Sundry Print Report of 10
12/27/2023

Well Name: HUERFANITO UNIT Well Location: T27N / R9W / SEC 25 / County or Parish/State: SAN

## **Subsequent Report**

Subject: RE: [EXTERNAL] Hilcorp P&A Variance Request: Huerfanito Unit 82M

#### **Current Schematic - Version 3**

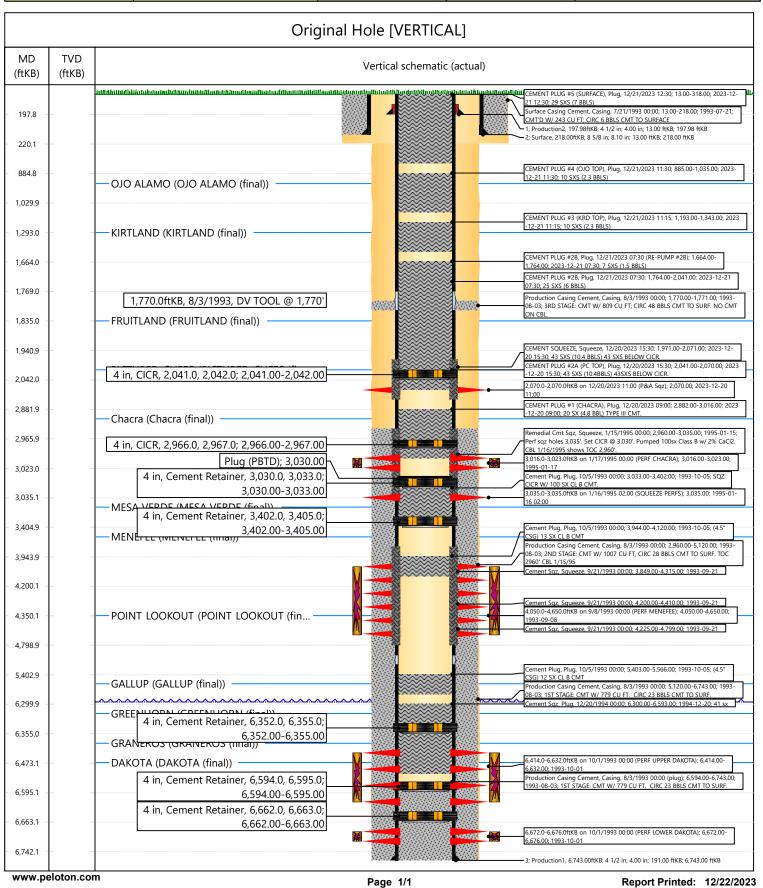
Monica/Kenny – Requesting approval to spot an additional 100' cmt after tagging Plug #2b low.

- 1. Repump 100' cmt for Plug #2b (CICR, FRD Top, DV Tool) from 1,664' 1,764' using 7sx 1.5bbl (Class III, 14.8ppg, 1.37 vield)
- 2. Plug #3 (KRD Top) | 150' inside cmt plug from 1,193' 1,343' using 10sx (Class III, 14.8ppg, 1.37 yield)
- 3. Plug #4 (Ojo Top) | 150' inside cmt plug from 885' 1,035' using 10sx (Class III, 14.8ppg, 1.37 yield)
- 4. Plug #5 (Surface Shoe) | 268' inside/outside cmt plug from surface to 268' using 64sx (Class III, 14.8ppg, 1.37 yield)
- 5. WOC top plug 4hr, cut off wellhead, weld P&A marker, confirm TOC, top off as needed.

NMOCD accepts for record with prior approval from the BLM
